Observation on Proposed Carrow Wind Farm, Co. Tipperary and Co. Limerick
An Coimisiún Pleanála Reference: PAX91.324164

**Observation on Proposed Carrow Wind Farm, Co. Tipperary
and Co. Limerick**

An Coimisiún Pleanála Reference: PAX91.3241

Figure 2: Proximity of 4 Proposed Turbines to Our Property and Equine Facilities

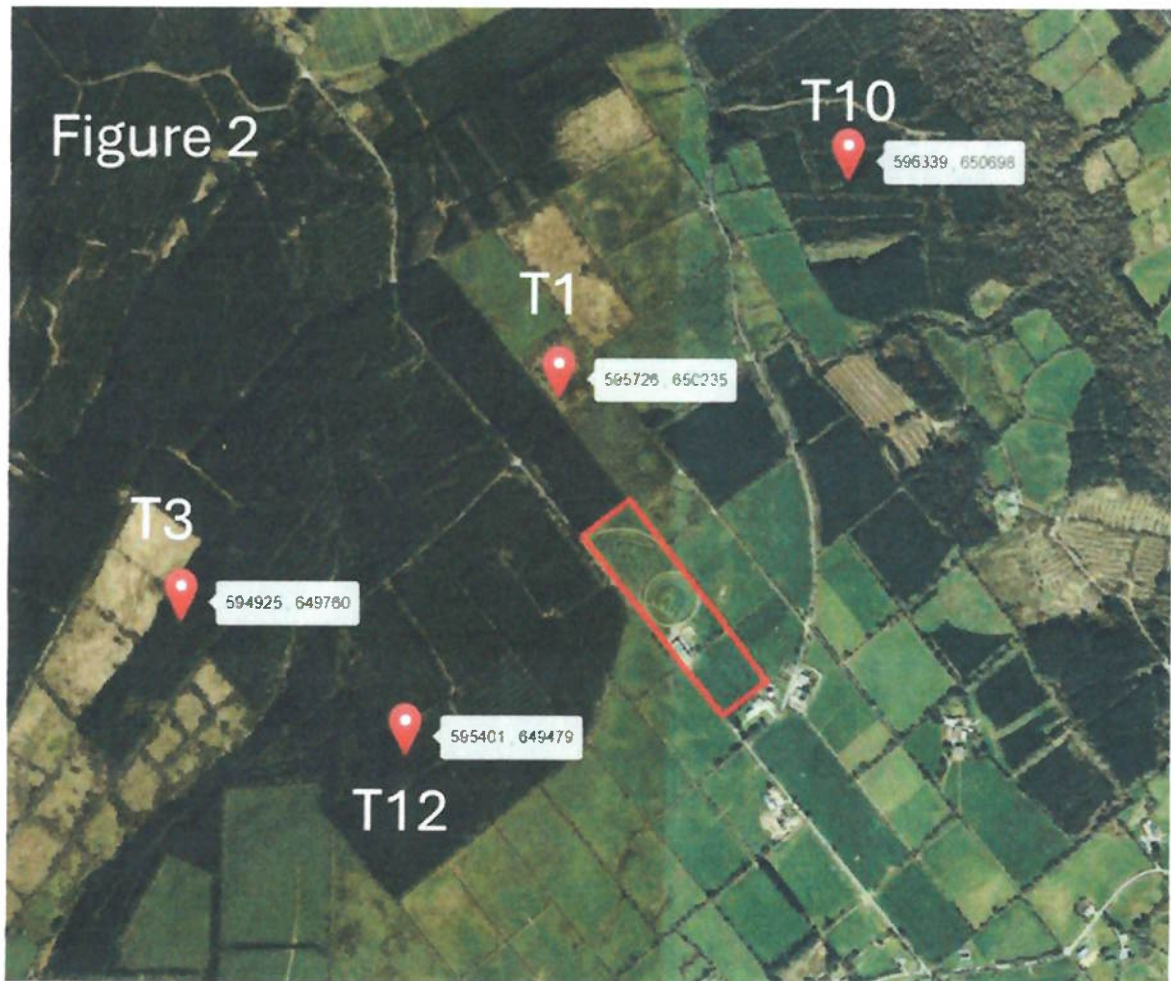
- **T01:** 265m from residential curtilage, 291m from the gallops, 580m from barns and equine infrastructure, and 735m from the farthest boundary of the holding;
- **T12:** 585m from residential curtilage, 610m from equine infrastructure, and 715m from the holding boundary;
- **T10:** approximately 823m from the holding;
- **T03:** approximately 870m from the holding.

Accordingly, both T01 and T12 fall within the 740m separation distance arising from the Draft Revised Wind Energy Development Guidelines (2019). While the Draft Guidelines specifically refer to residential curtilage, the operational reality is that the proposed turbines would directly affect the entirety of an established residential and equine-training environment, including gallops, paddocks, barns, turnout areas and daily outdoor working activities.

- T01: approximately 265m from the nearest point of the residential curtilage, approximately 291m from the closest section of the gallop, approximately 580m from barns and associated equine infrastructure, and approximately 735m from the farthest boundary of the holding;
- T12: approximately 585m from the residential curtilage, approximately 610m from barns and associated equine infrastructure, and approximately 715m from the farthest boundary of the holding;
- T10: approximately 823m from the holding;
- T03: approximately 870m from the holding.

Figure 3: 3B

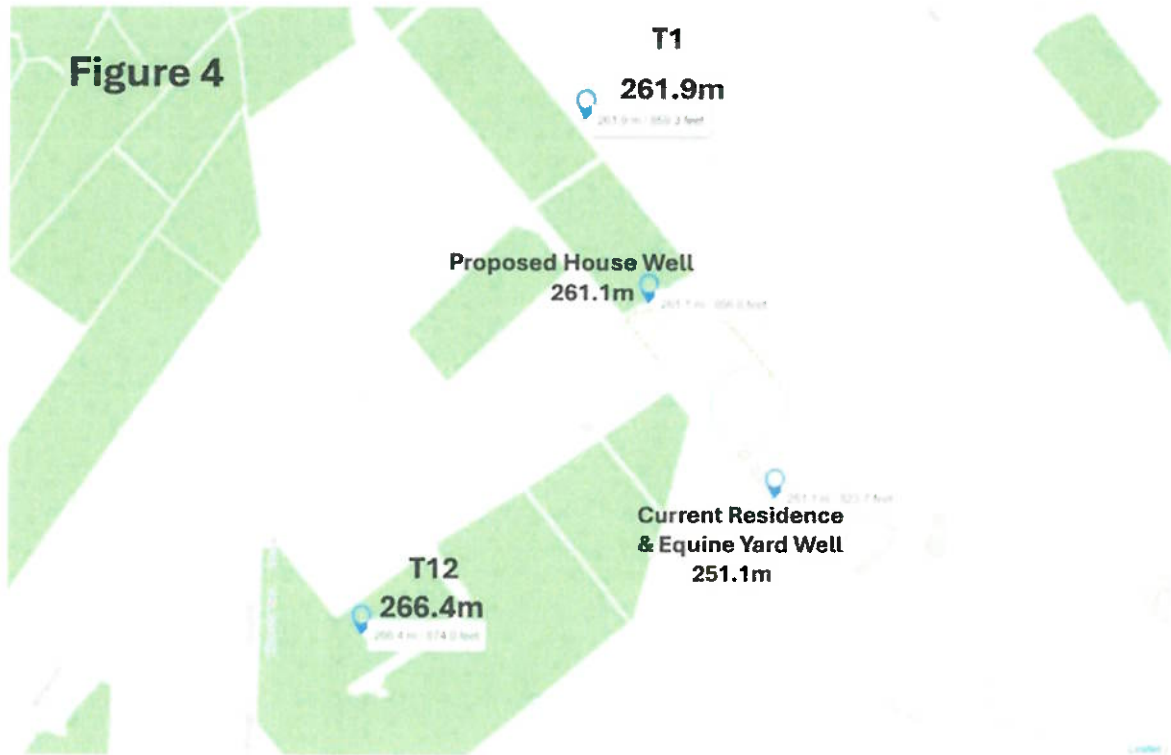
Figure 3; Photos 3A illustrate the proposed location of T01 in direct relation to the gallops. Photo 3B shows an existing operational turbine of approximately 135–150m at a comparable separation distance of approximately 265m and provides a realistic illustrative representation of the visual scale and dominance likely to arise at such close proximity. The proposed turbine at T01 would be substantially larger again at 185m in height.

Photo of existing operational Turbine at Glencarbry farm, 3.2km from our property

This turbine is approx. 135-140m (Glencarbry has two different height turbines). The photo was taken from road with an elevation difference of approx. 14.6 thus there is an increase of approx. 30-35m of height for proposed windfarm turbines at 185m.
